**Meghan Pump Station (RFCSP)  
Solicitation Number: CO-00645  
Job No.: 19-1006**

**ADDENDUM 2  
October 17, 2023**

Project information block including: SAN ANTONIO WATER SYSTEM, MEGHAN PUMP STATION, ELECTRICAL CONDUIT SCHEDULE SHEET 1 OF 2, QUIDDITY logo, and project details like DATE: AUGUST 2022, DGN. BY: SHUDDSON.

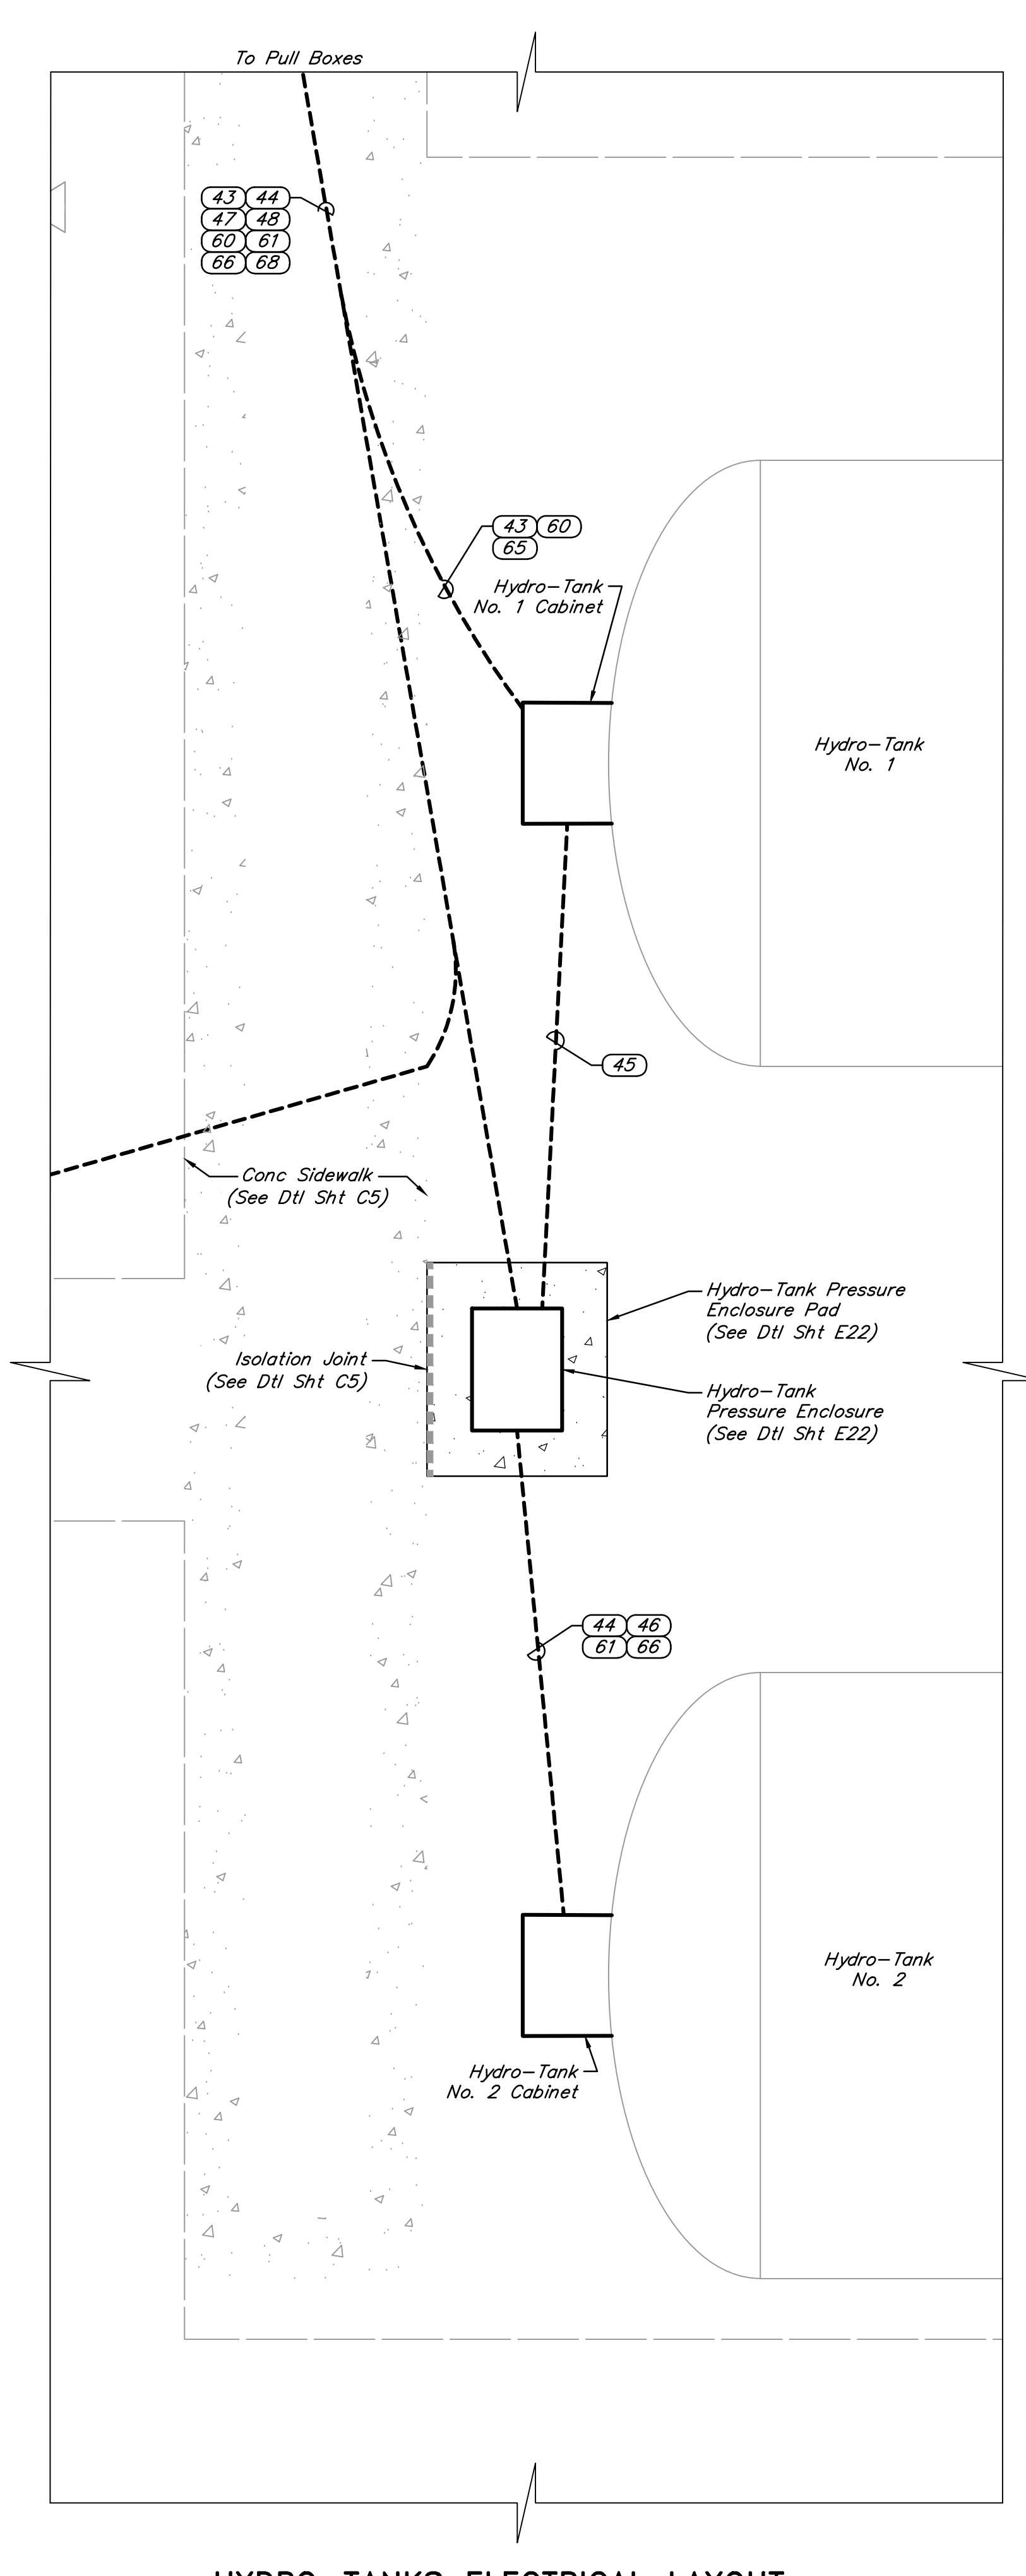
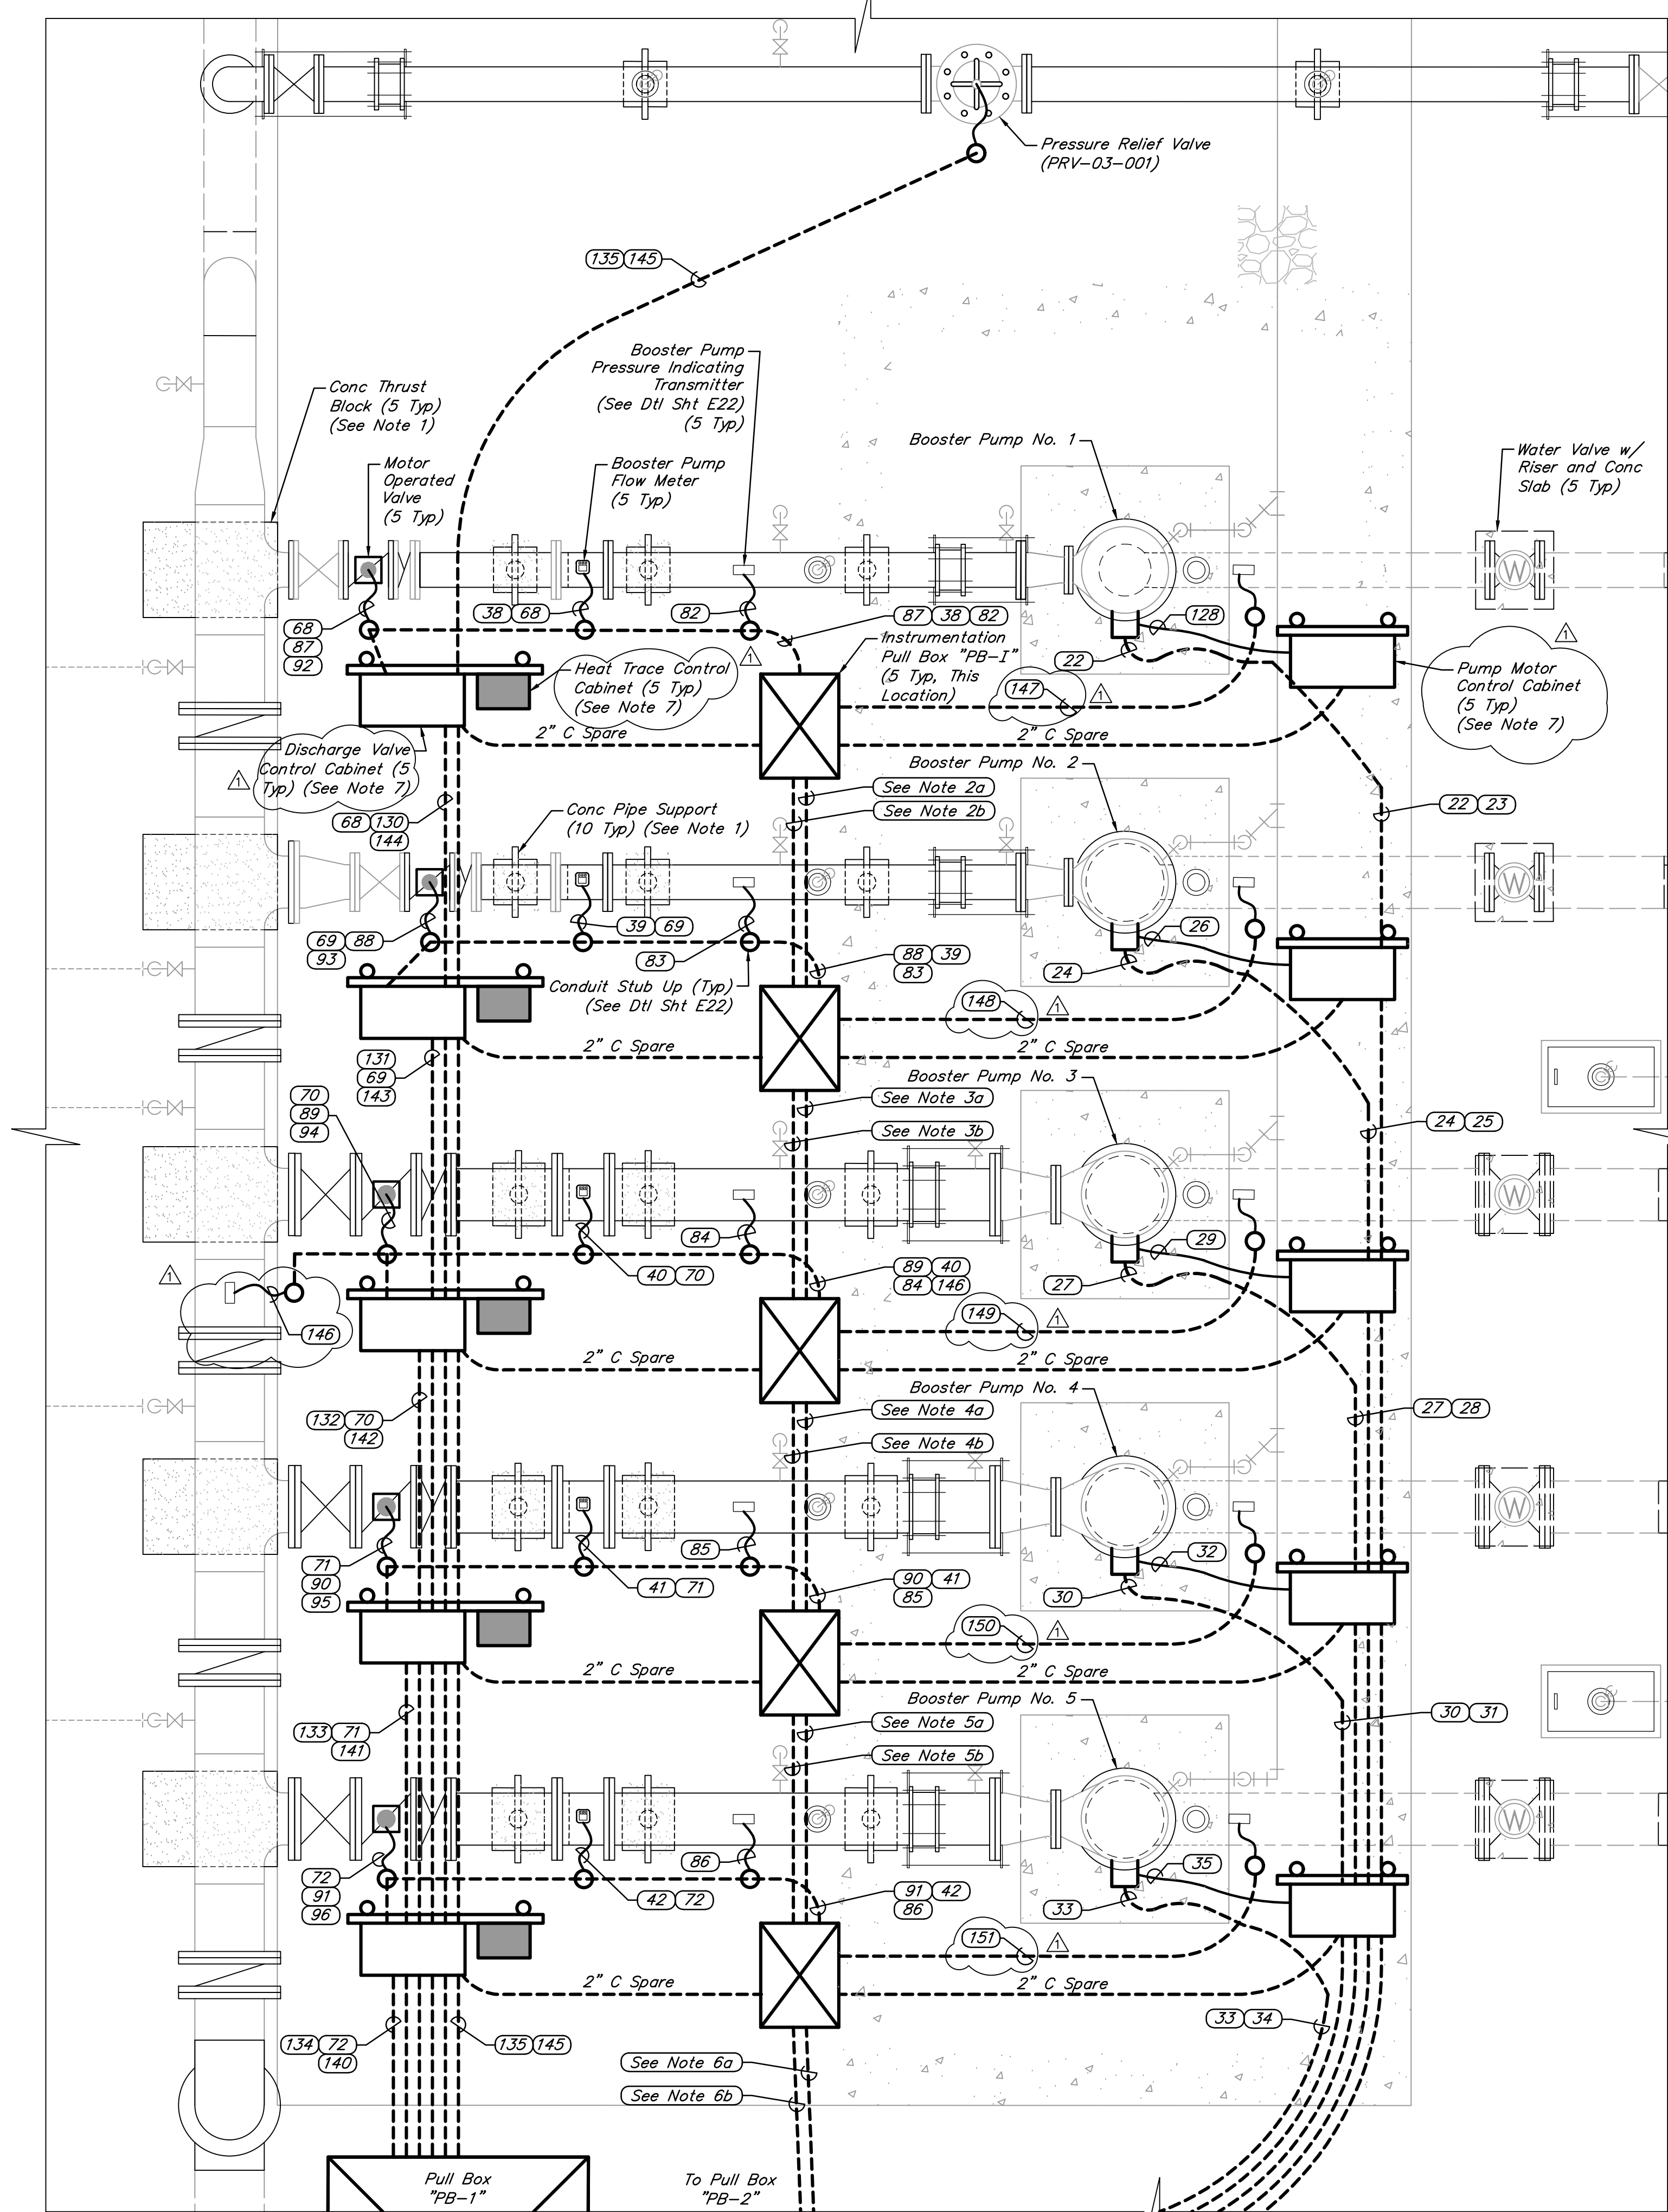
- 59.** On sheet E9 is conduit #42A combining conduits #38 through #42? It does not add up.

- 60.** The discharge header pressure transmitter PIT 03001 shown on M5 and I4 is not listed on the conduit schedule nor does E8 show the discharge header pressure transmitter & associated cabling back to the Autosensory panel. Please review and revise.

*Response: Conduit #42A (3") shall include 62-#14 + 21-#12 GND + 11 Pr. #18 STP routed between Autosensory Panel and PB-2. Conduit #97 (2") shall be a spare conduit routed from Autosensory Panel to PB-2. See #6 & 7, Changes to the Plans, in this addendum. The indicated revision to the plans have been made. Conduit Schedule (E9 & E10) have been updated.*

*Response: See #7 & 8, Changes to the Plans, in this addendum. The indicated revision to the plans has been made. Circuit for discharge header pressure transmitter has been added to plans (E8) and conduit schedule (E10).*

SHEET NO.  
**E3**  
 37 OF 67

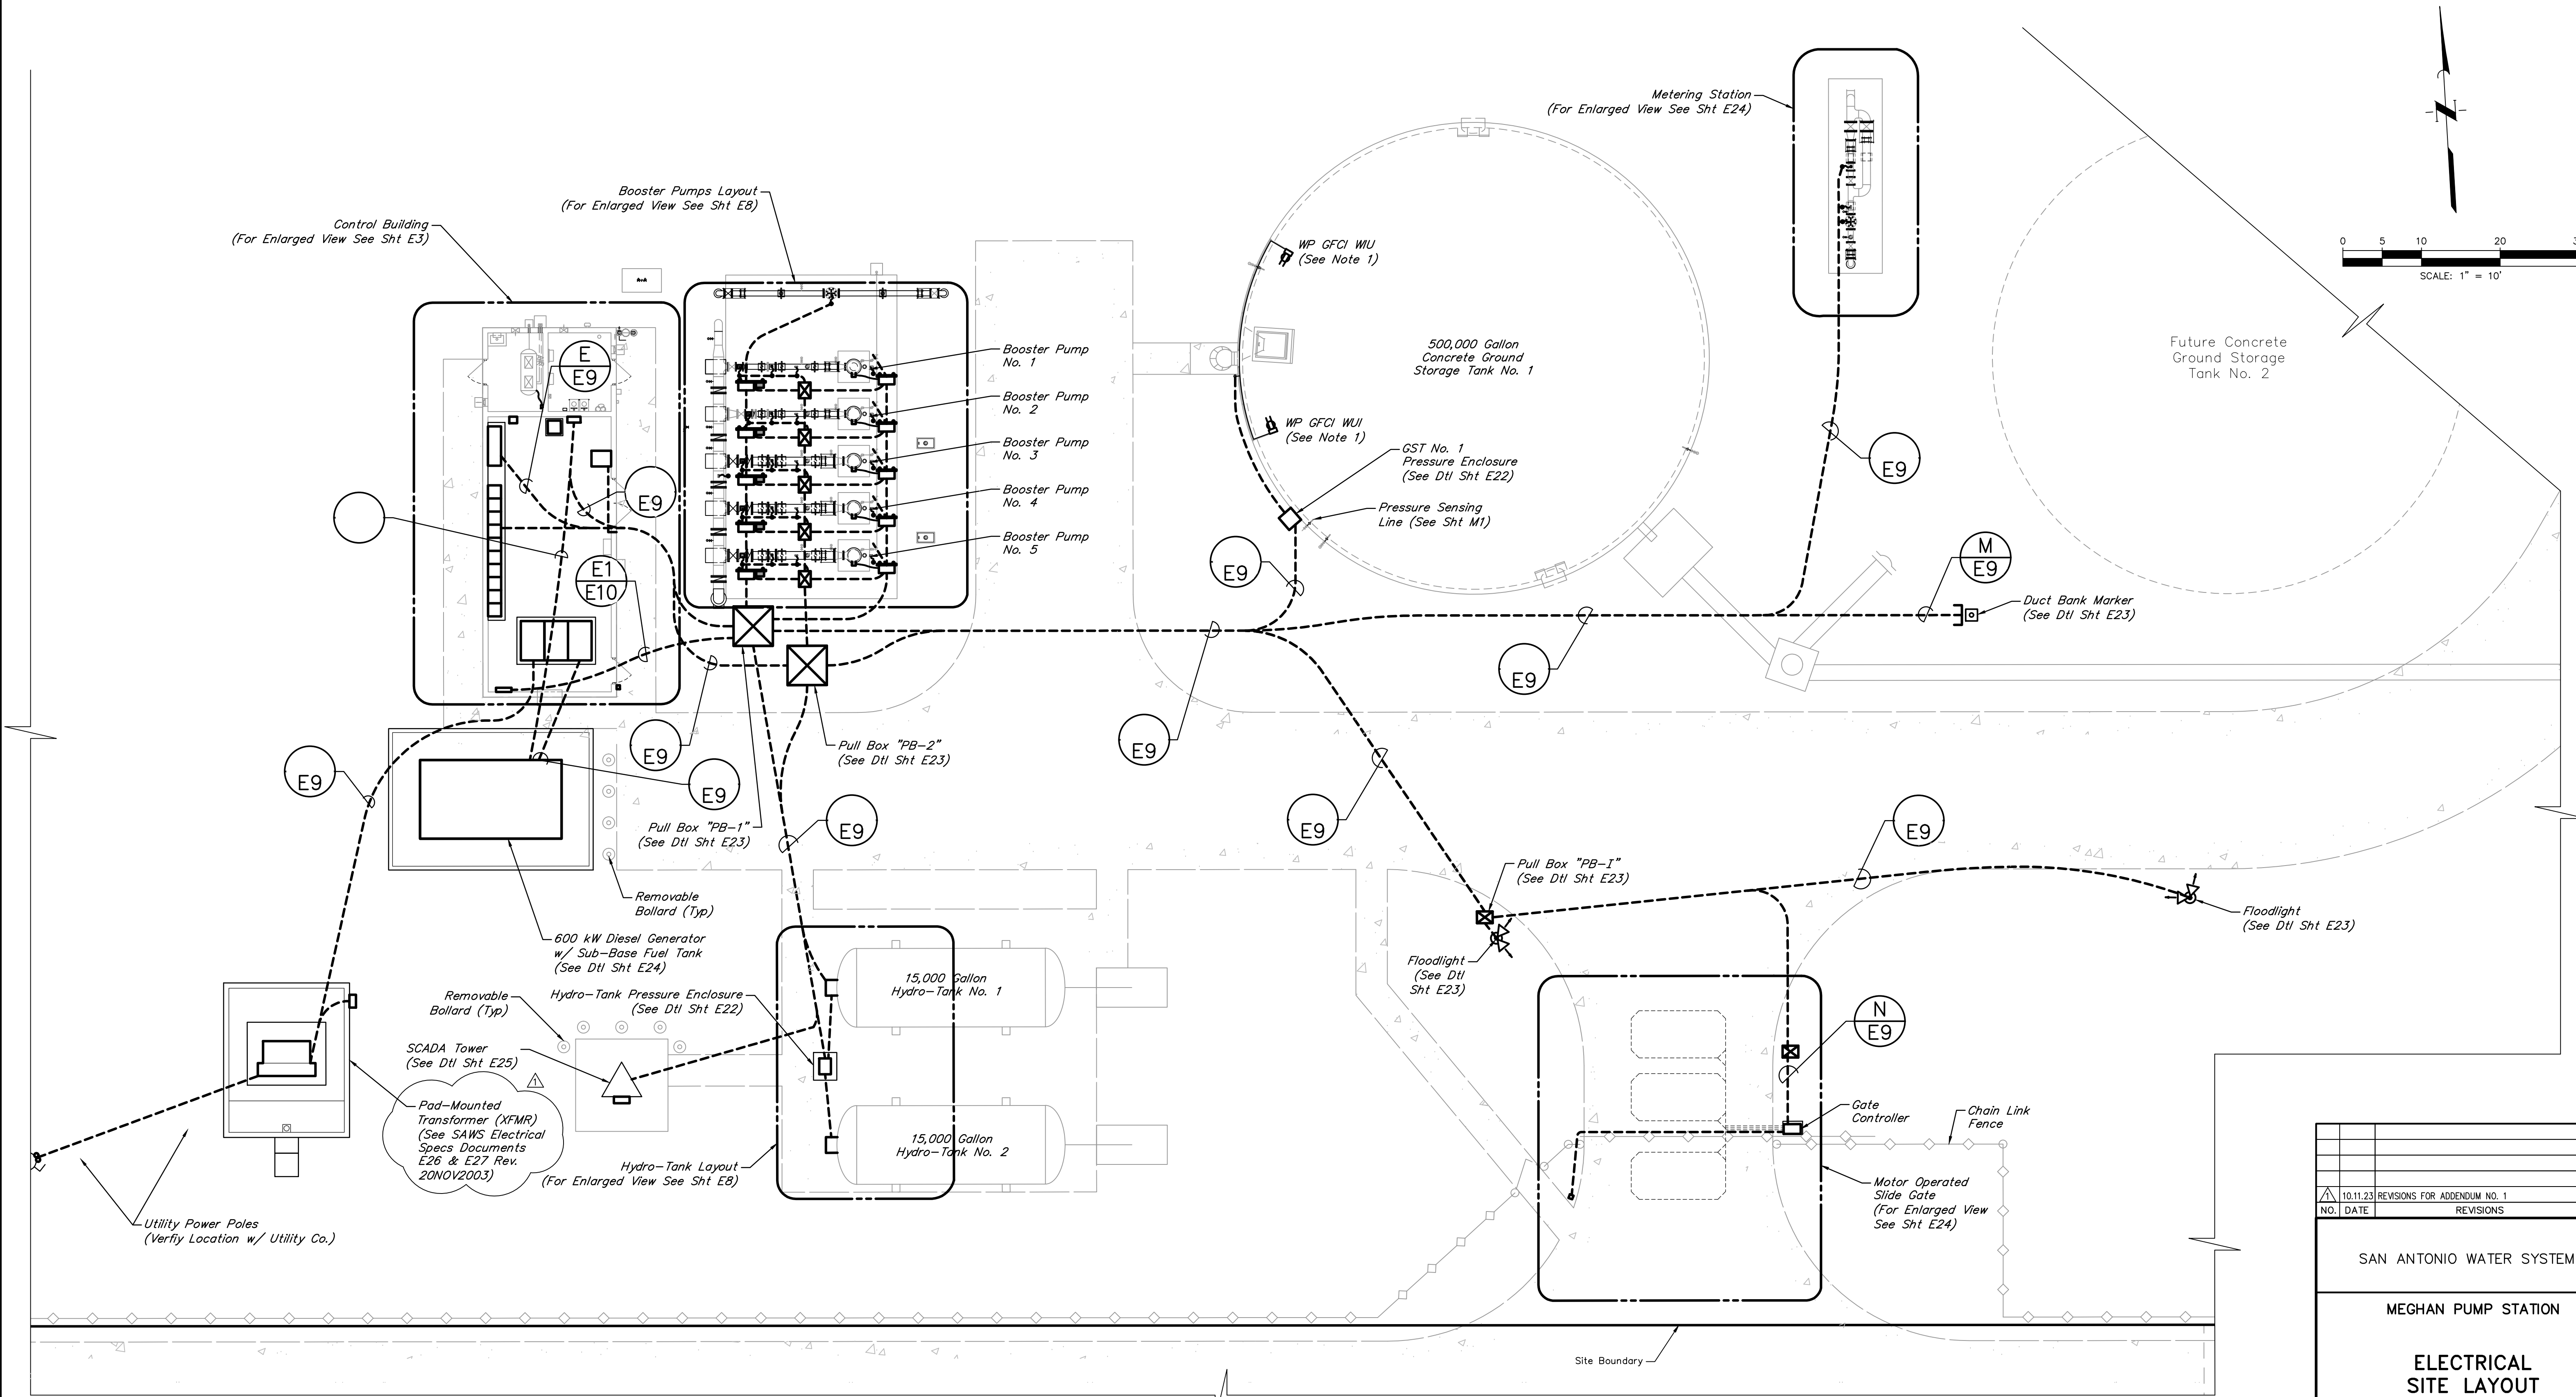
- 63.** The conduit/circuit from the auto sensory panel to the MCC/SCP selector switch control shown on E15 does not show up on the plan drawings or on the conduit schedule. Please review and advise.

*Response: See #7 & 9, Changes to the Plans, in this addendum. The indicated revision to the plans has been made. Circuit for MCC/SCP Selector Switch has been added to Plans (E3) and Conduit Schedule (E10).*
